SERVICE BULLETIN 117

SUBJECT: Hot Restart Difficulty and/or Hard Starting on Ariens Rotary Mowers

MODELS OR TYPES AFFECTED: TVS105-53038C, TVS105-53039C
TVS105-53038D, TVS105-53039D

MAIN NOZZLE
TUBE

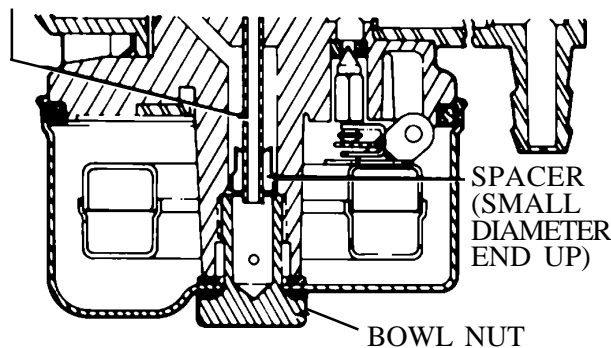
Field complaints of hard starting or restarting a warm engine on the subject engine models have been occasionally reported by the field organization. In order to eliminate these starting problems we recommend the installation of Tecumseh service kit, part number 730219, which consists of a carburetor fuel spacer and a new bowl nut. This kit can be obtained from your Tecumseh source of supply. Remove the old bowl nut (do not remove carburetor bowl or disturb bowl O ring), install the fuel spacer into the carburetor and install the new nut. Instructions below will also be furnished in the box with the parts.

- A. Disconnect spark plug wire.
- B. Drain fuel from fuel tank.
- C. Tip lawnmower on its side, carburetor side up.
- D. With a box end wrench, remove the original bowl nut & gasket. Install spacer per reverse illustration. Position original gasket on new bowl nut and install. Tighten bowl nut.
- E. Set mower up, fill fuel tank and connect spark plug wire.
